Subject: Core Operating Limits Report, Braidwood Unit 1 Cycle 10 Sequence
 Number 5

Braidwood Unit 1, Cycle 10, Sequence Number 5

TODI No. NFM0100083
Seq No. 5
Page 1 of 17

Subject Braidwood Unit 1 Cycle 10 Core Operating Limits Report in ITS Format and W(z) Function

Figure 2.6.2.a

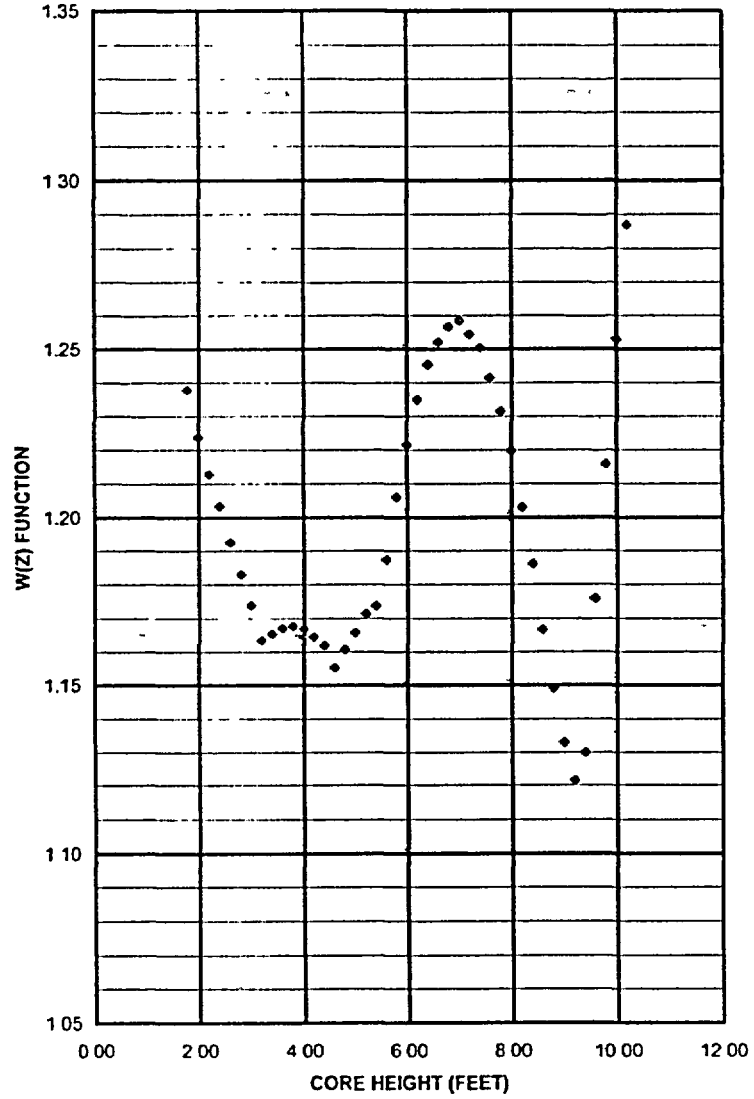
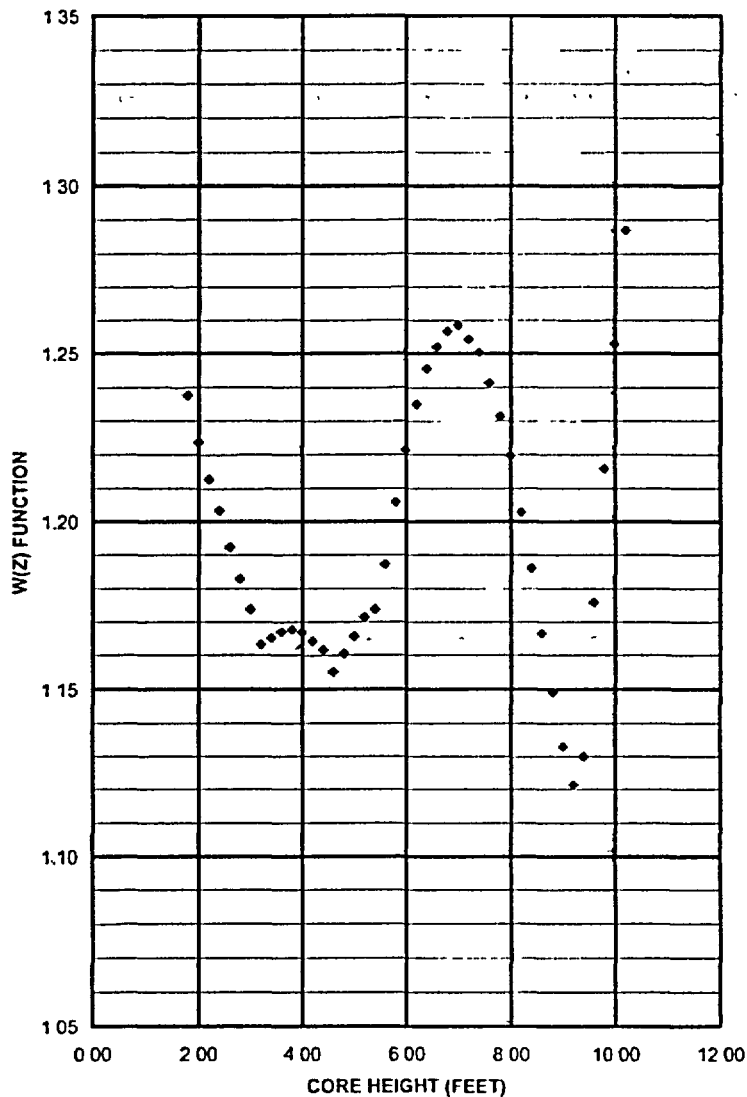
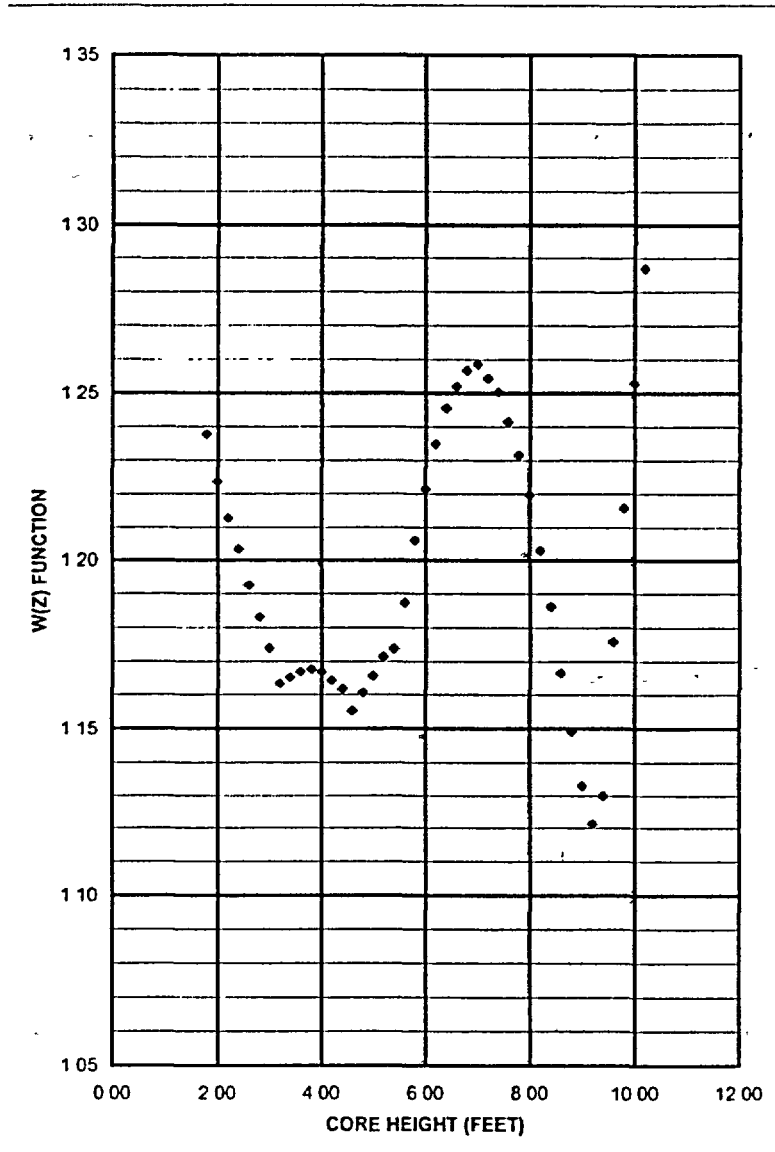
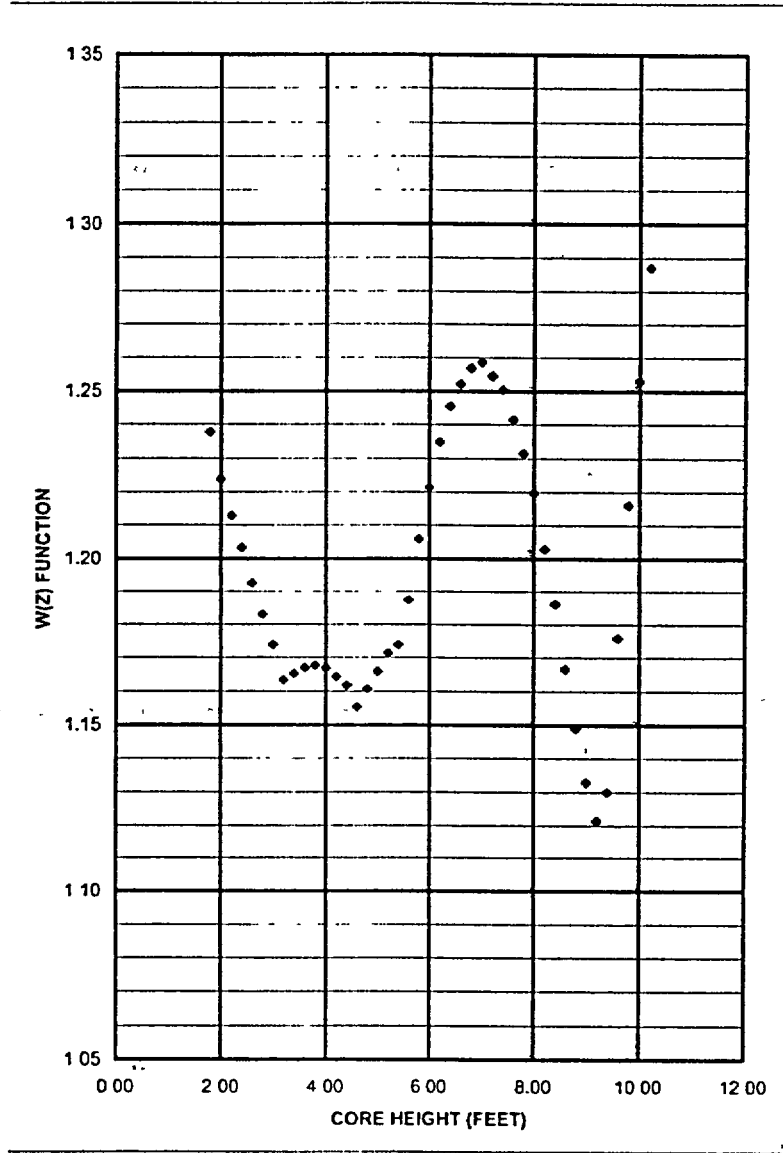
The purpose of this letter is to transmit the Core Operating Limits Report (COLR) for Braidwood Unit 1 Cycle 10 Sequence Number 5, in accordance with Technical Specification 5.6.5, "Core Operating Limits Report (COLR)". This revision of the COLR was recently implemented and revises item 2.5.4, item 2.6.2 and corresponding Figures 2.6.2.a through 2.6.2.d, and item 2.13.2. These changes include: 1) deleting a control bank park position that will not be used, 2) updating W(z) data by providing data for burnups of 22,000, 23,000 and 25,000 MWD/MTU, and 3) editorial changes.

- Item 2.5.4 of the COLR is being revised to remove the last line of the table which reads "231 vs. 116"
- Item 2.6.2 of the COLR and the corresponding Figures 2.6.2.a through 2.6.2.d are being revised with newly updated W(z) data
- Item 2.13.2 of the COLR is being revised for updated wording

b) When PDMS is Inoperable, $W(Z)$ is provided in Figures 2.6.2.a through 2.6.2.d.

The normal operation $W(Z)$ values have been determined at burnups of 20000, 22000, 23000, and 25000 MWD/MTU to support operation after 22000 MWD/MTU.
